ADDENDUM 2 Via E-Mail DATE: January 27, 2020

Contract 19-C-00051; Howard F. Curren AWTP Methanol Storage Tank Replacement

City of Tampa

2 SECTION M-01 1"=4'-0"

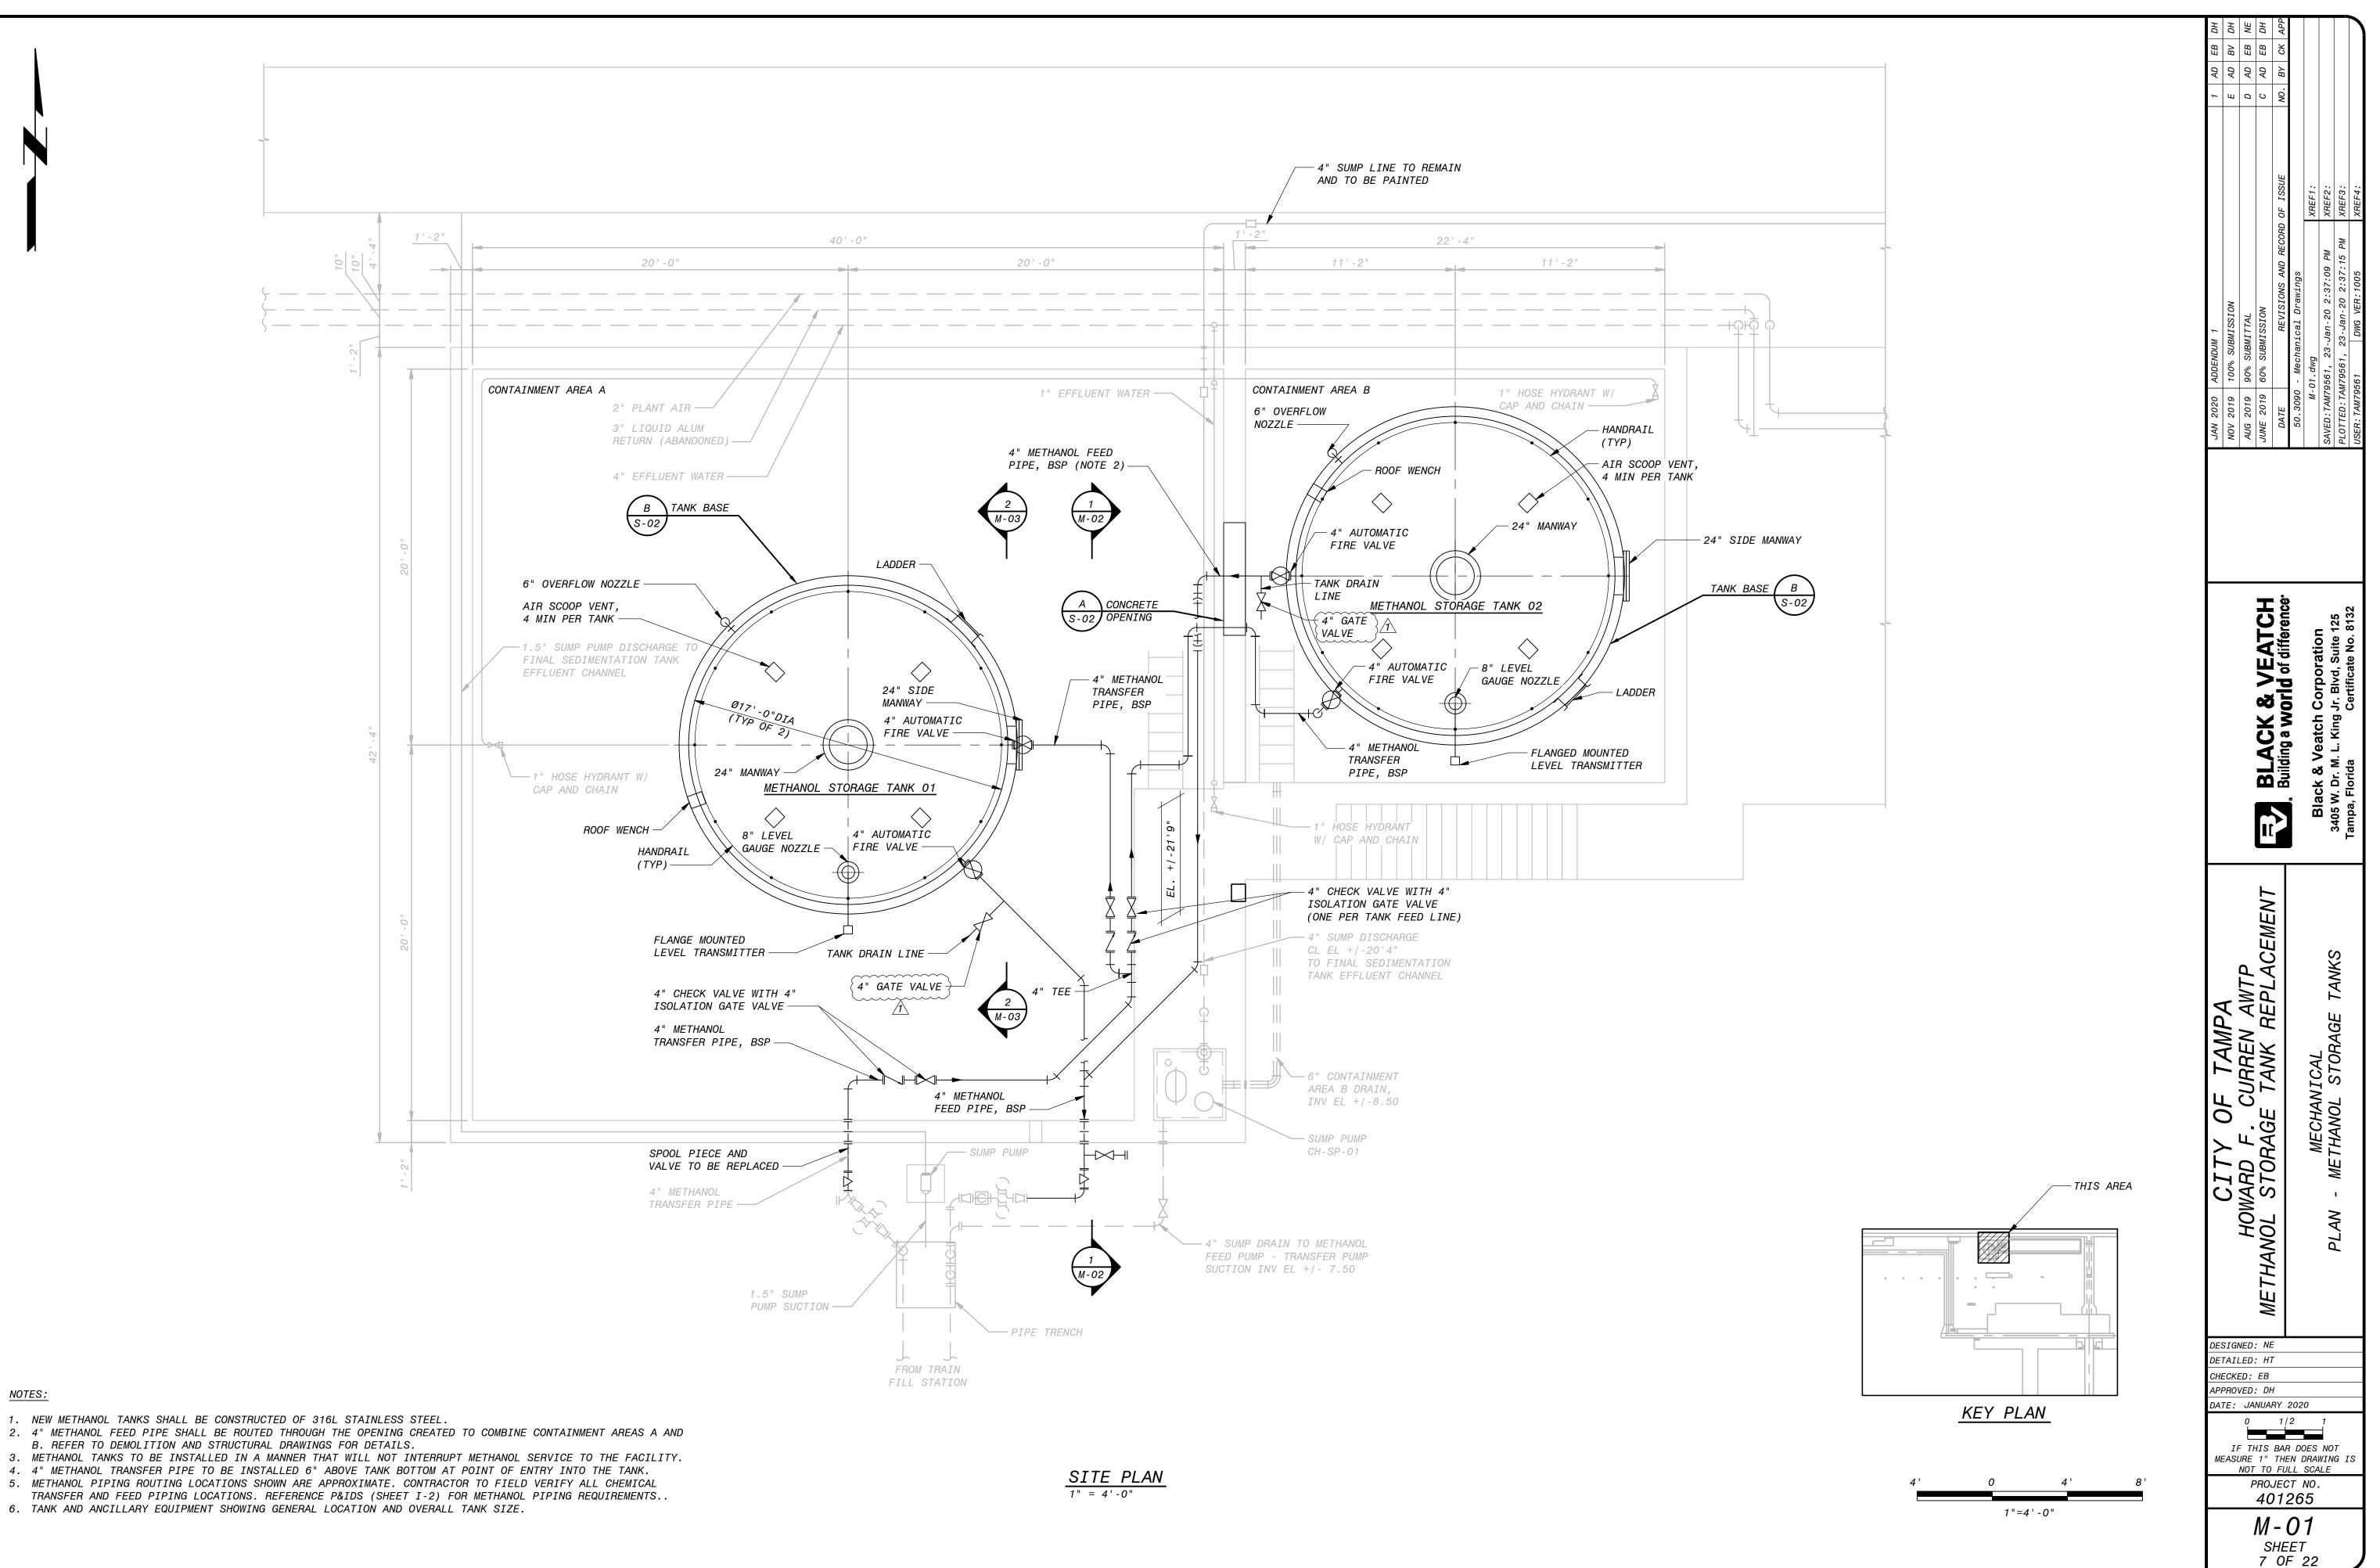
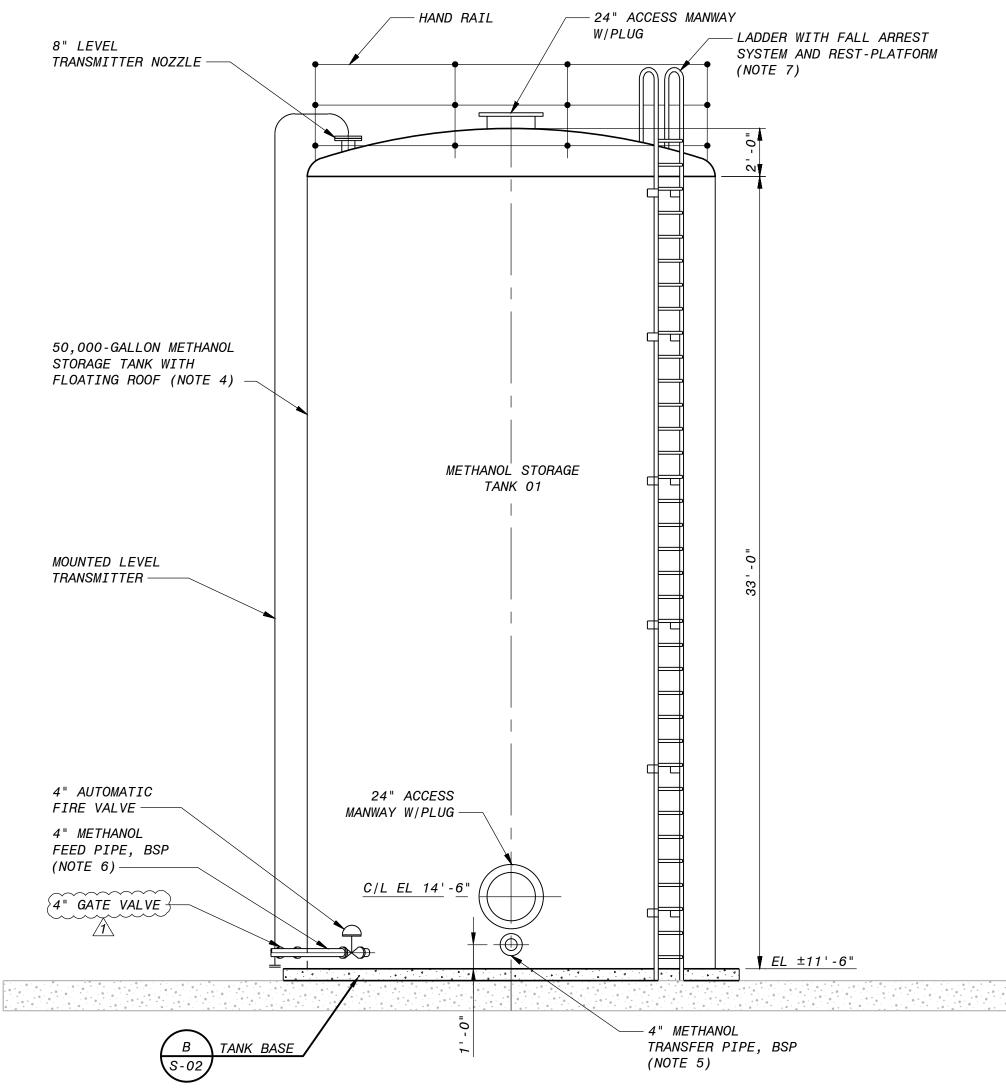
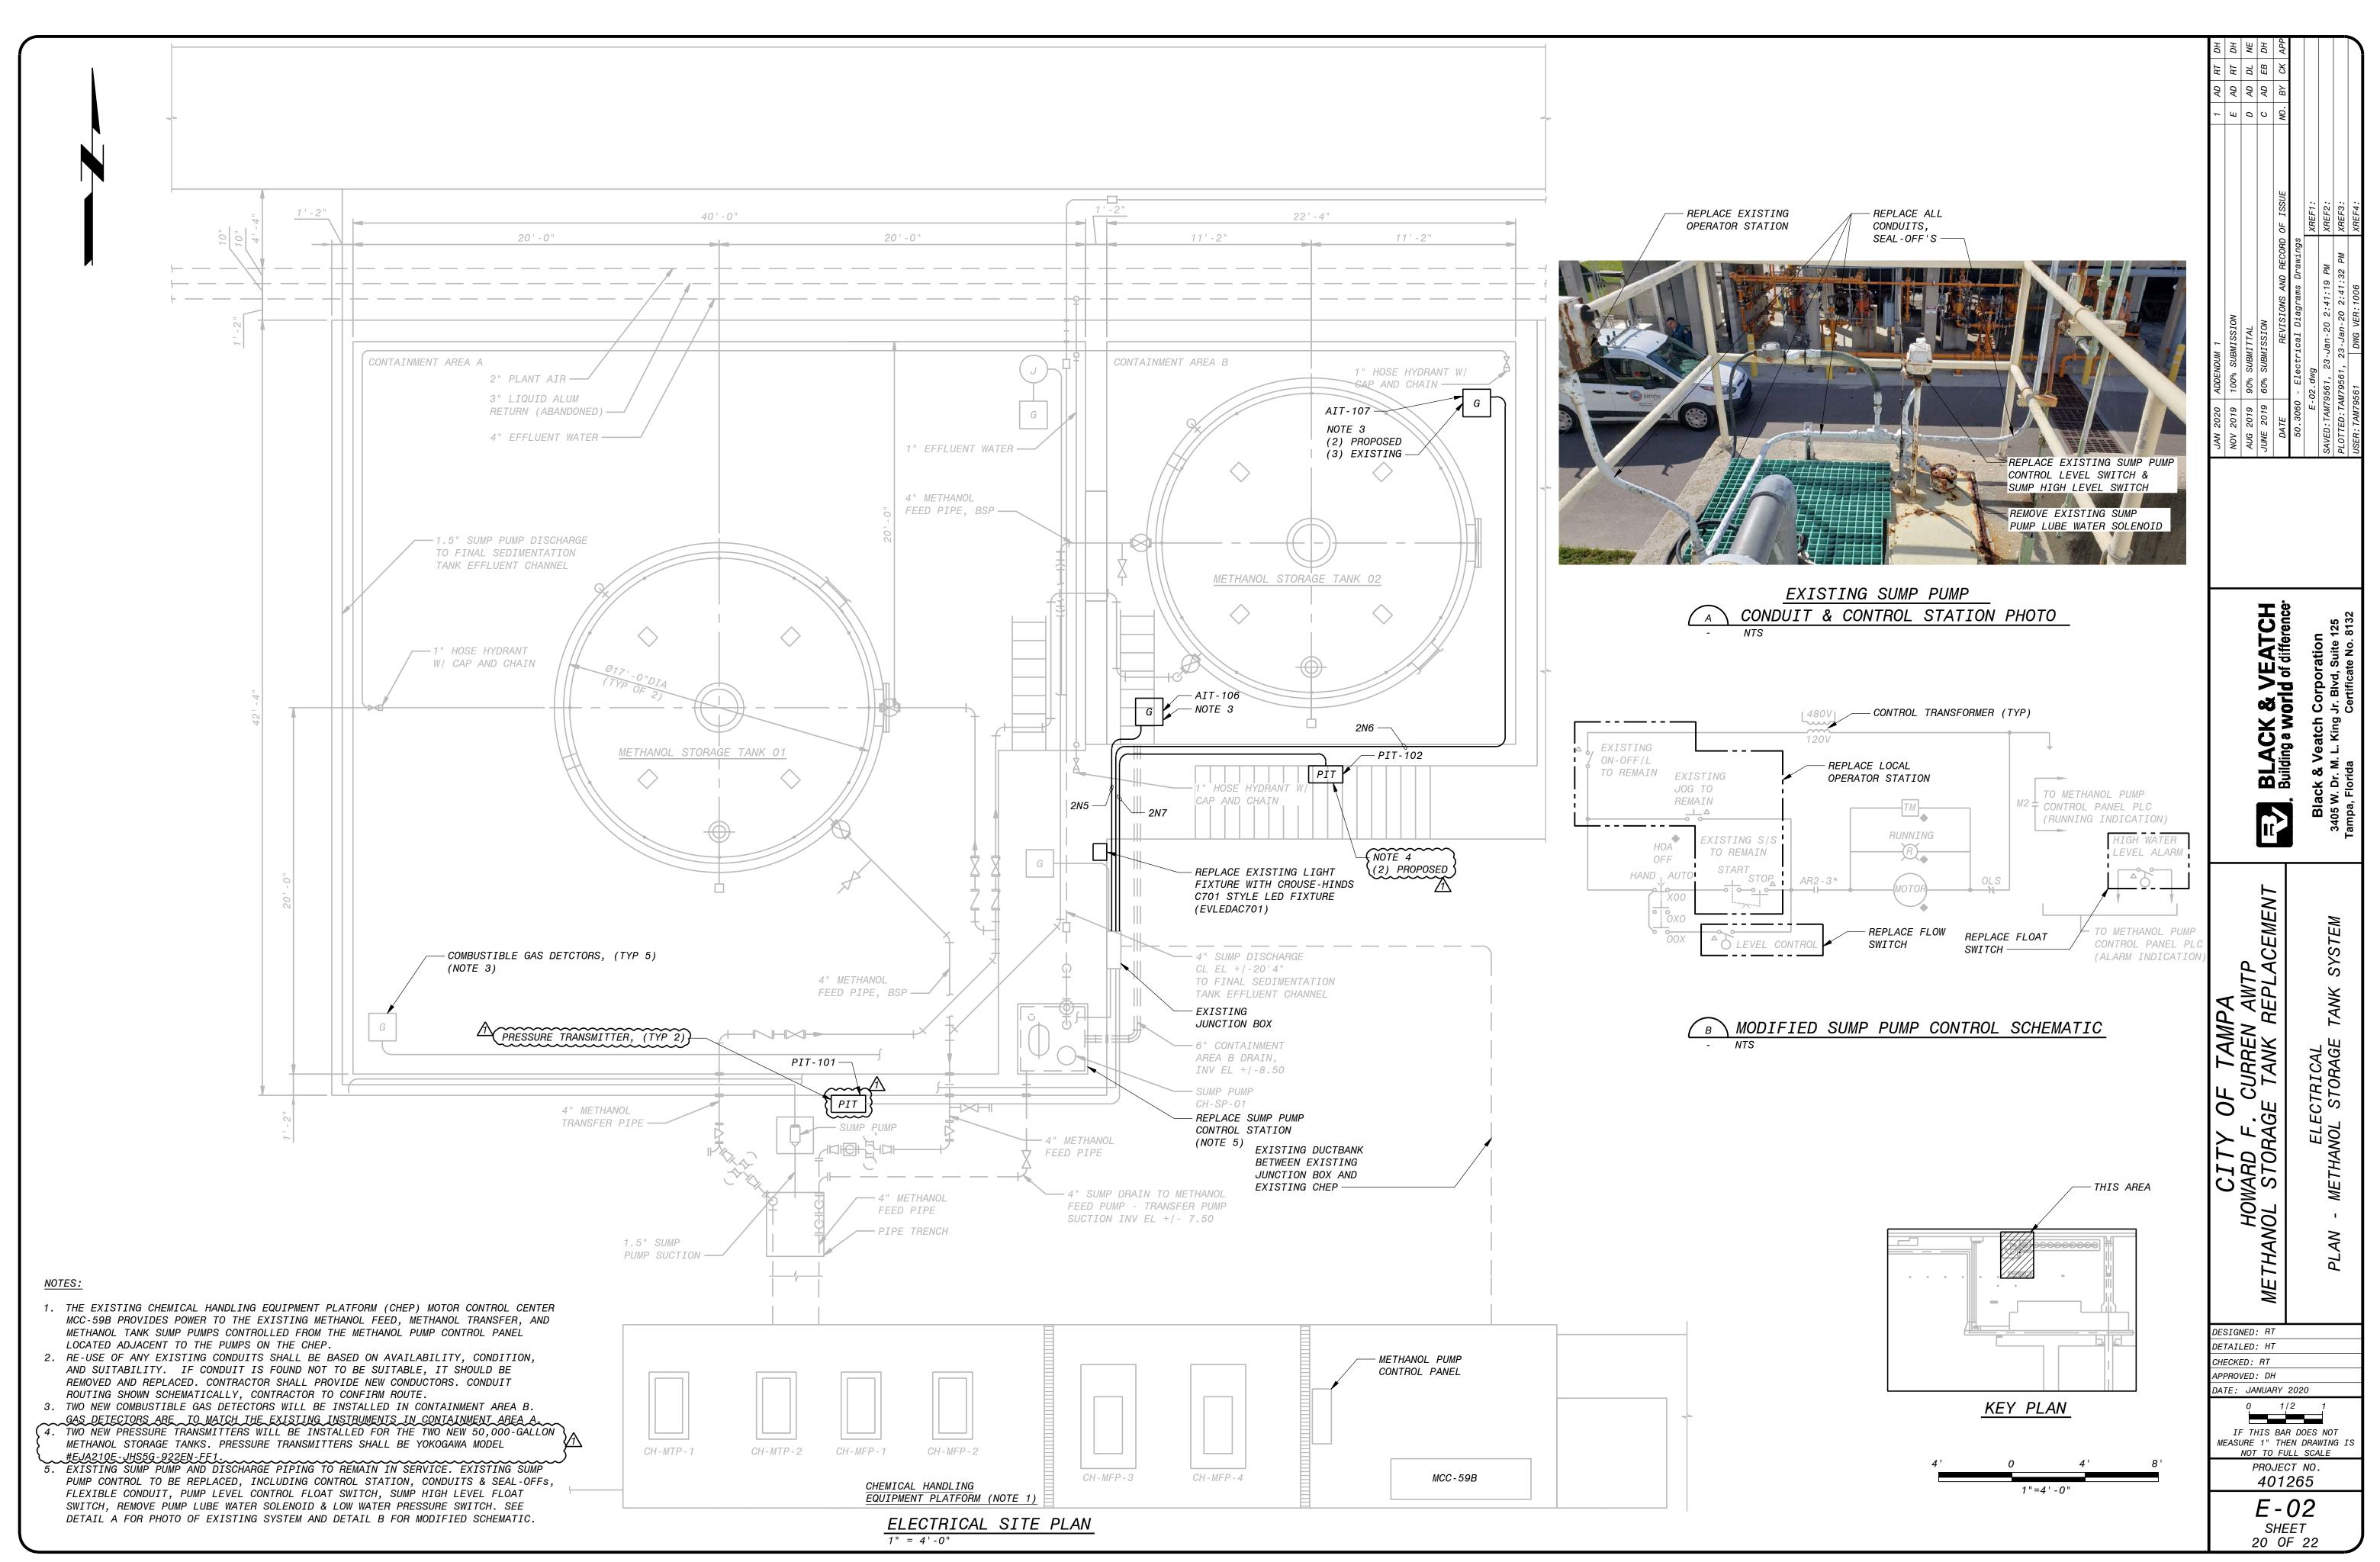
Item 2: Replace Plan Sheet M-01 MECHANICAL PLAN –METHANOL STORAGE TANKS with the attached Plan Sheet M-01.

Item 3: Replace Plan Sheet M-03 MECHANICAL SECTION – METHANOL STORAGE TANK (TYPICAL) with the attached Plan Sheet M-03.

- 1. NOT ALL PIPE SUPPORTS HAVE BEEN SHOWN.
- 2. NOVOLAC VINYL ESTER WITH GRAPHITE FILLER PROTECTION SYSTEM TO COAT CONCRETE FLOOR SURFACE OF CONTAINMENT AREA INCLUDING CONCRETE TANK BASE, CONCRETE STEPS, EQUIPMENT BASES, INSIDE SUMPS AND INSIDE CONTAINMENT WALLS TO THE TOP, INCLUDING HORIZONTAL SURFACES. THE COATING SHALL EXTEND TO 6" BELOW THE OUTSIDE TOP OF CONTAINMENT WALL. REFER TO SPECIFICATION 09940.

- 3. REFER TO P&ID (SHEET I-2) DRAWINGS FOR ADDITIONAL REQUIREMENTS. 4. METHANOL TANK HAS AN INTERNAL FLOATING ROOF WITH AT LEAST 4 VERTICAL ANTI-ROTATION CABLES AND A WRENCH SYSTEM.

- 5. 4" METHANOL TRANSFER PIPE TO BE INSTALLED 6" ABOVE TANK BOTTOM AT POINT OF ENTRY INTO THE TANK. 6. 4" METHANOL FEED PIPE TO BE INSTALLED FLUSH WITH TANK BOTTOM. REFER TO SPECIFICATION 13215 FOR ADDITIONAL REQUIREMENTS.

- 7. A FALL ARREST SYSTEM AND REST-PLATFORM(S) AT OSHA RECOMMENDED INTERVALS ARE REQUIRED.
